Re: Responses to EPA's November 30, 2009 Email Questions
UniFirst Property Indoor Air Quality and Vapor Intrusion Assessment
Wells G&H Site, Woburn, Massachusetts

Attachment
Responses to Email from Joe LeMay, November 30, 2009

Questions from October 9, 2009 VI scope of work:

FIGURE A

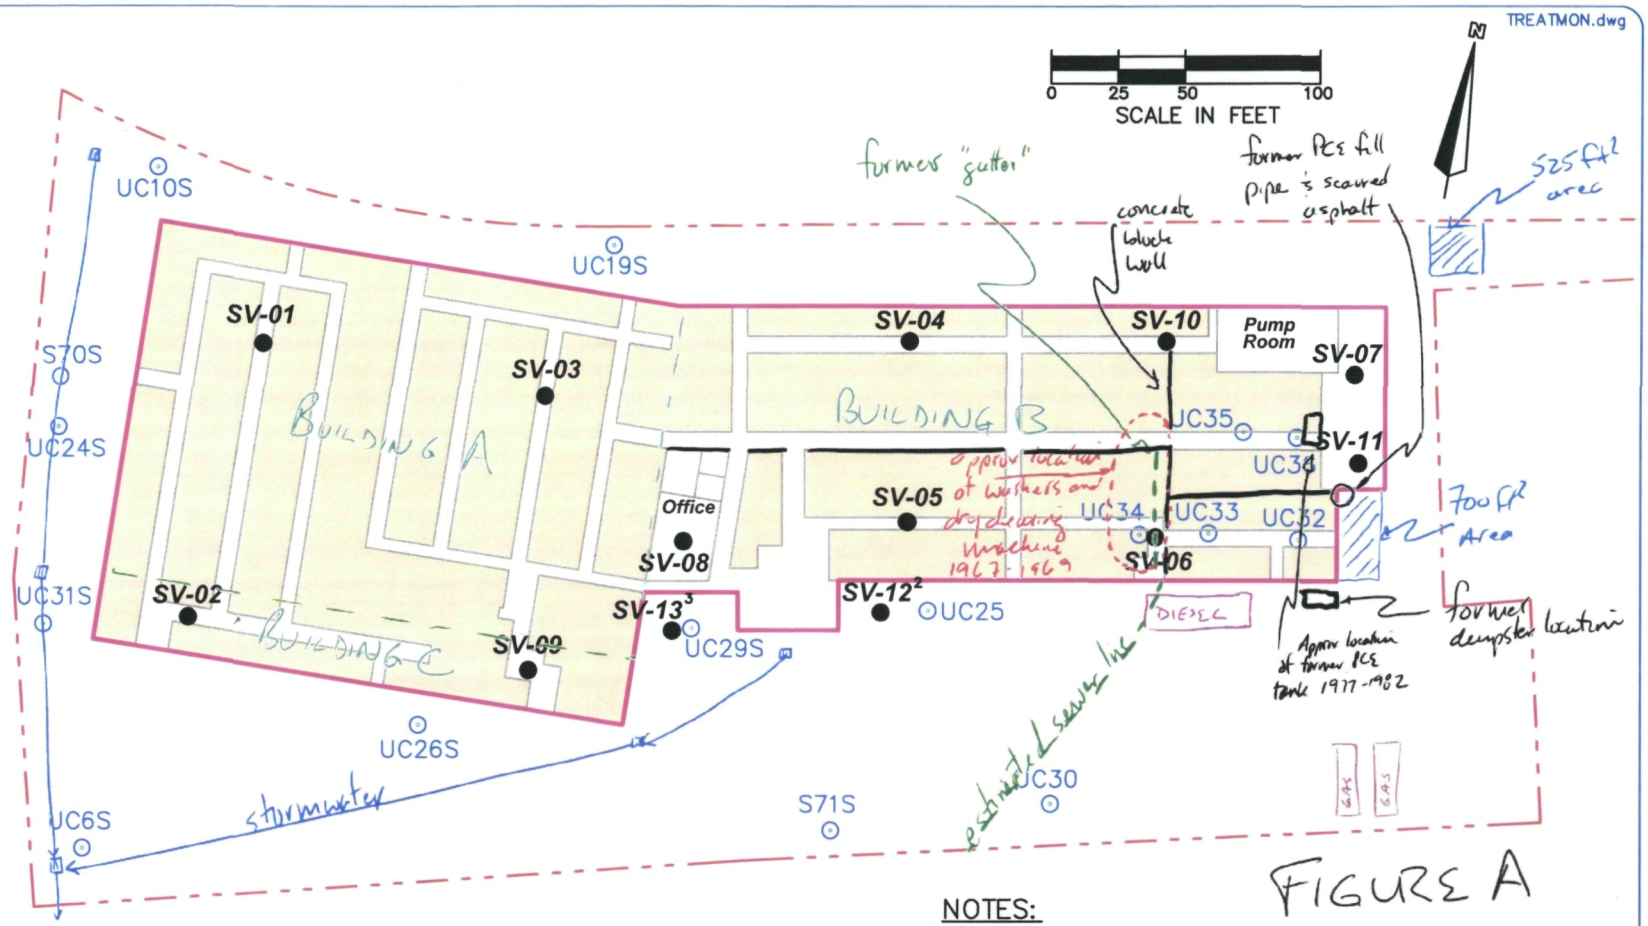
1) Please illustrate on Figure 4 or 3, the following:
   a. the locations of one drycleaning machine and several conventional washing machines (SOW, p. 4) within Building B between 1967 and 1969 for "white shirt laundry";
   b. the locations of PCE chemical storage, and any other chemical storage, within Building B and/or A between 1967 and 1969;
   c. the locations of PCE diatomaceous earth (SOW, p. 4) filter within Buildings B and/or A between 1967 and 1969;

e. the location and extent of a spill of 100 gallons of PCE (SOW, p. 4) inside Building B;

f. the locations and extents of the two "release" areas (approximately 525 ft2 and 700 ft2, respectively) (SOW, p.5);

2) Please identify the location of the sewer line that reportedly transported waste water from the drycleaning operations (pg. 3 of Croatti cover letter to Ruda). Please also identify the location of the diesel tank which was removed in Decemver 1986. See below excerpt.

7) Please illustrate the location of the tank that overflowed, and the location and dimensions of the large room that housed the tank (Enclosure 8 - Draft Environmental Assessment by ERAS, Inc., pg. 7). See below excerpt.

9) Please illustrate the location of these one of two stormwater drains in the front of the parking lot. Please also illustrate the location of the swales (which these stormwater drains drained into) and where the swales discharged into the Aberjona River (Enclosure 8 - Draft Environmental Assessment by ERAS, Inc., pg. 7). See below excerpt.

The approximate locations of the washing machines and the dry cleaning machine are shown in Figure A. It is expected that the PCE used in the dry cleaning machine would have been stored near that machine.

The "release areas" described in the SOW were taken directly from the 1994 Soils Report and were meant to reflect the context in which those areas were defined in that report. The release areas are described as the waste oil area (525 ft^2) and the area south of the loading dock (700ft^2), both of which are shown on Figure A.

The location of the diesel tank, based on Figure 2-1 of the 1994 Soils Report previously submitted to EPA, is shown on Figure A. Since the sewer line was exposed by the excavation of the tank, the line must exit the building in that area. The sewer line connects to a trunk line that runs east to west along Olympia Avenue.

The 5,000 gallon PCE tank was located in the east end of the building, near the former loading dock as illustrated on Figure A, based, for example, on Figure 2-1 in the 1994 Soils Report previously submitted to EPA. The "large room" that housed the tank was located at the east end of Building B, to the north of the boiler room and garage area. Concrete block interior walls, illustrated in Figure A, would have defined the western and southern edges of the room referred to in the ERAS Report.

The property storm drain system is illustrated on Figure A, based on Figure 2-1 in the 1994 Soils Report previously submitted to EPA. None of these drains originate near the loading dock at the east end of the building (possibly the ERAS report mistakenly referred to the loading dock on the south side of the building, but UniFirst does not believe that drums of solvent were handled at this loading dock). The locations of any

FIGURE B

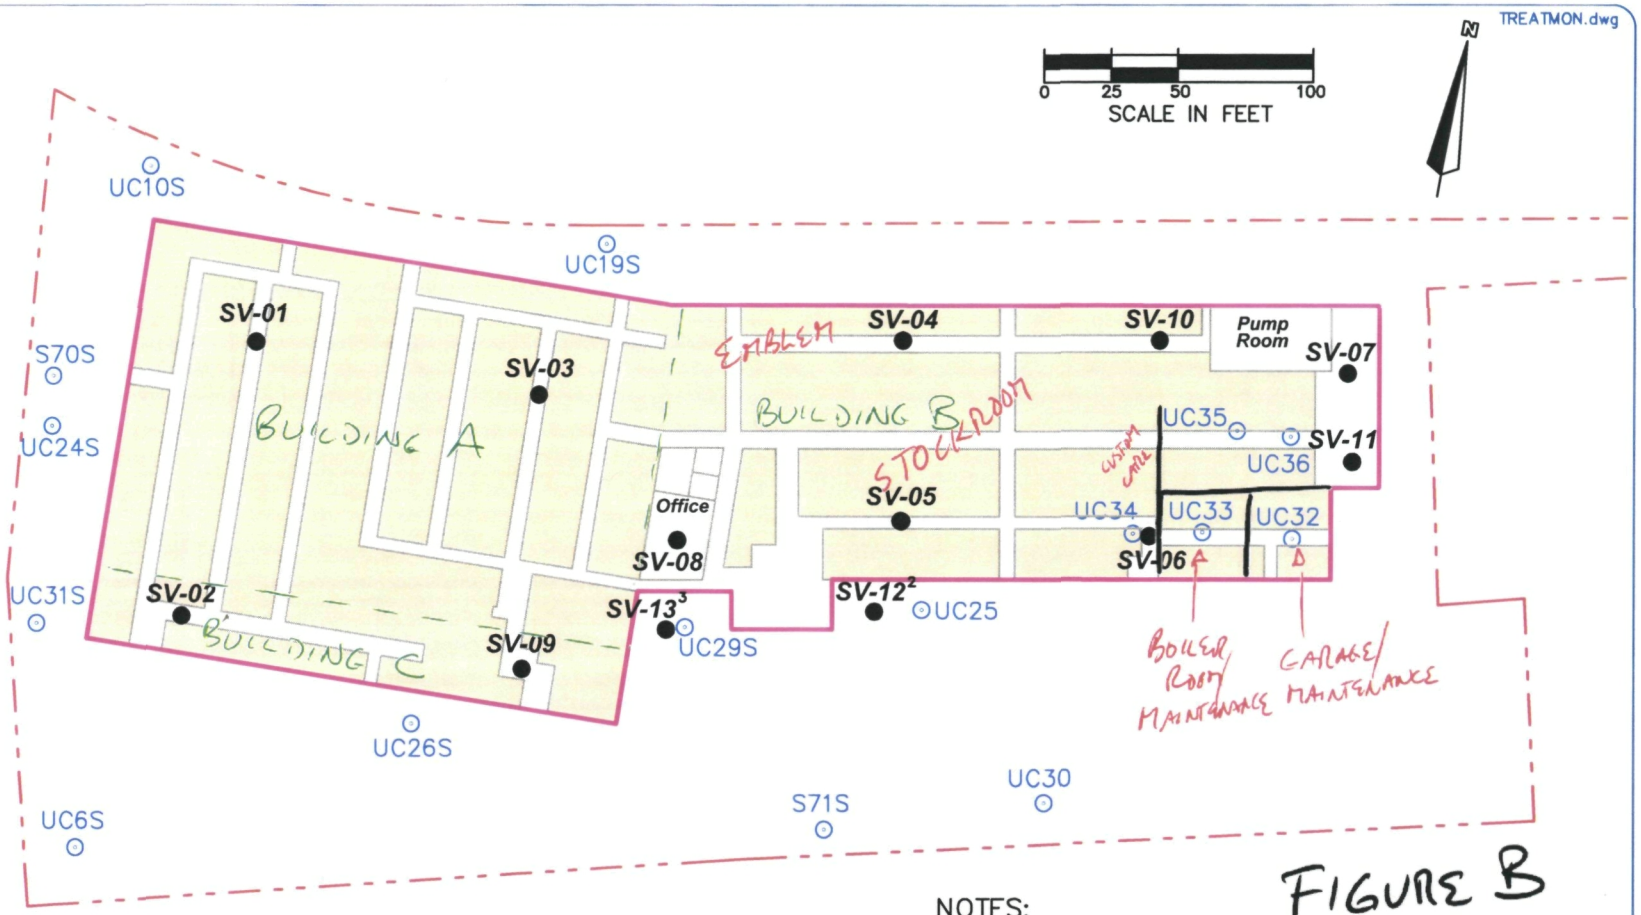
3) Please illustrate the locations within the building for storing cleaning supplies (used within the building and distributed for use outside the property) (Enclosure 8 - Draft Environmental Assessment by ERAS, Inc., pg. 4). See below excerpt.

11) Please identify the location of the following rooms/areas: Stockroom, Emblem Area, Storage Area, Matenance Area, Custom Care Area (Enclosure 9 - Hazardous Substance Summary and SDMS). See below excerpt.

Figure B illustrates the general location of operations during the late 1960s.

The general locations of these areas are illustrated on Figure B.

DRAWN: G.L. DATE: 6-9-78 DRAWING NO. S-1
SCALE: AS NOTED CHKD:

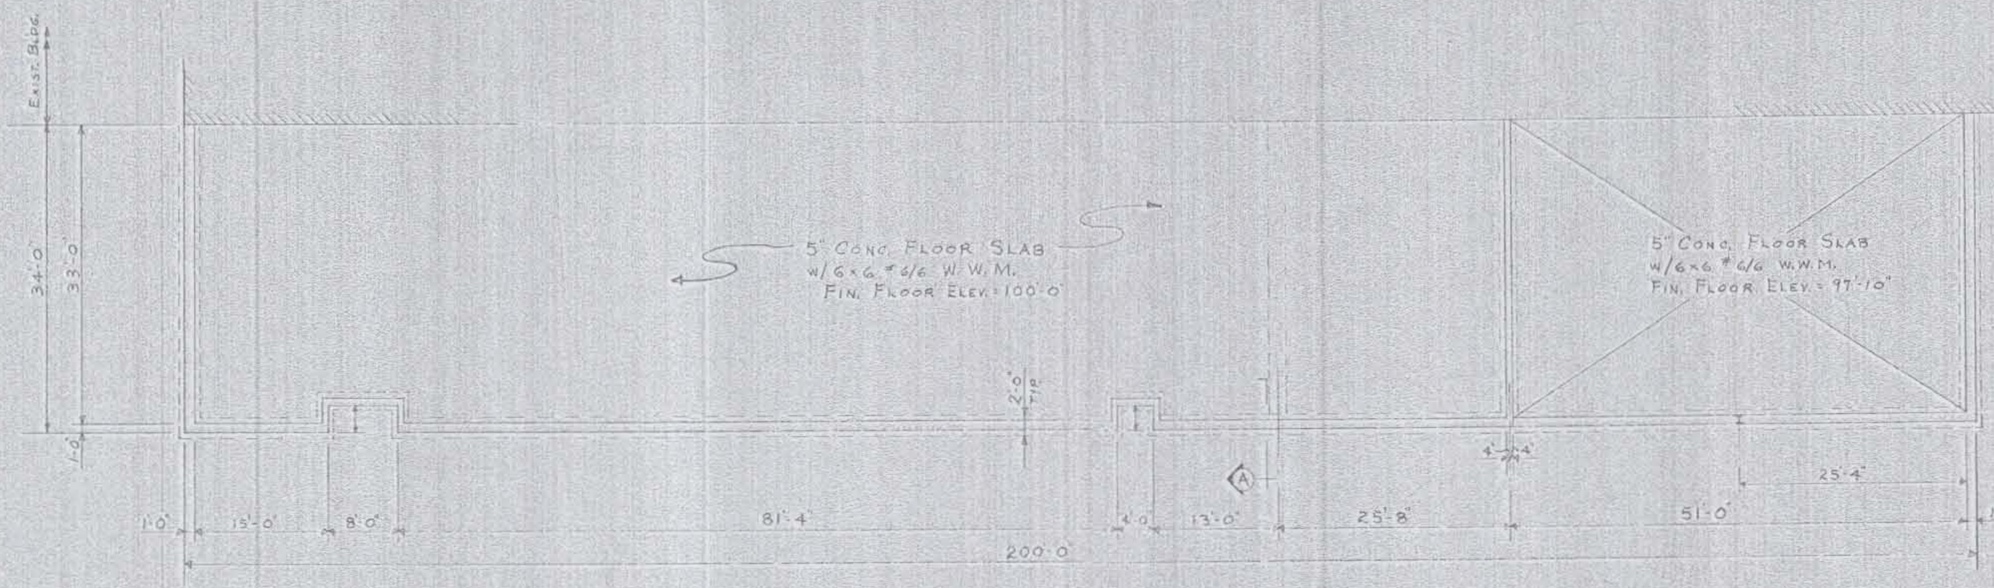
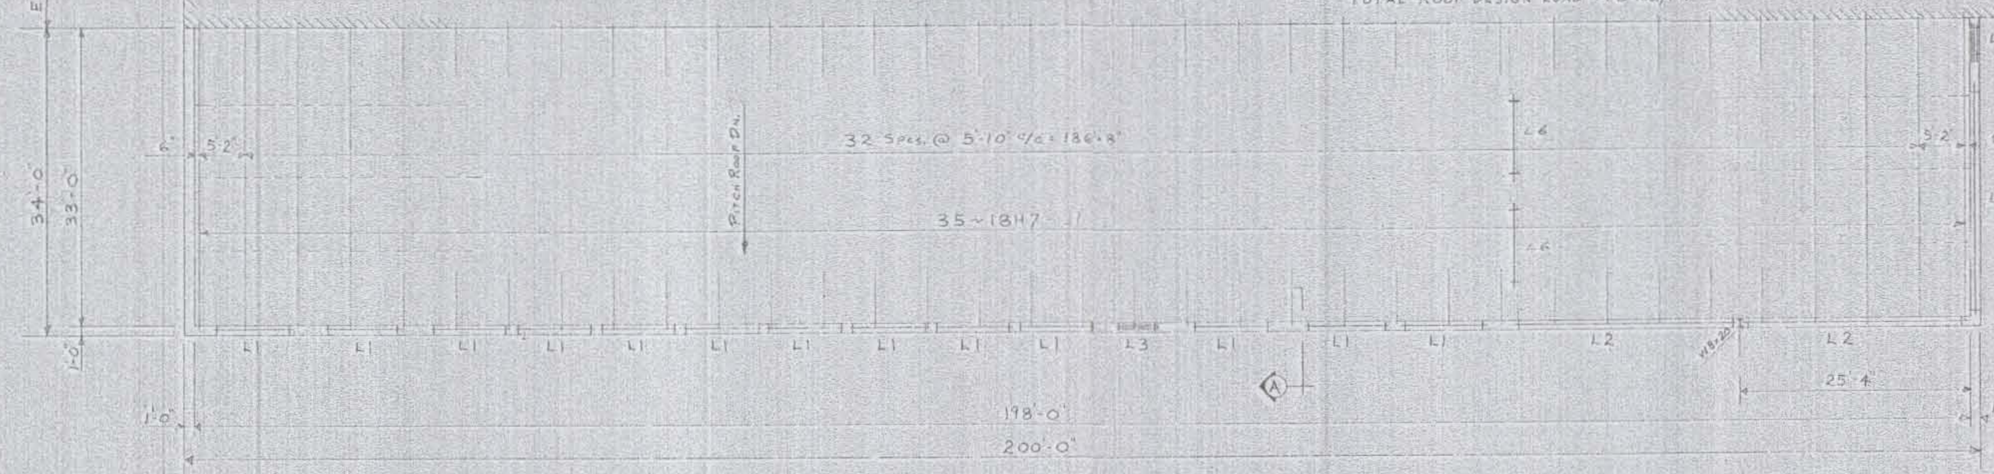
k. the depths and locations of foundation footings/ walls for each portion of the building (e.g. A, B, C, etc) as well as the eastern concrete retaining wall;

A 1978 design drawing for Building C includes a section illustrating the footings, with design depth data. No additional building foundation information can be located at this time.
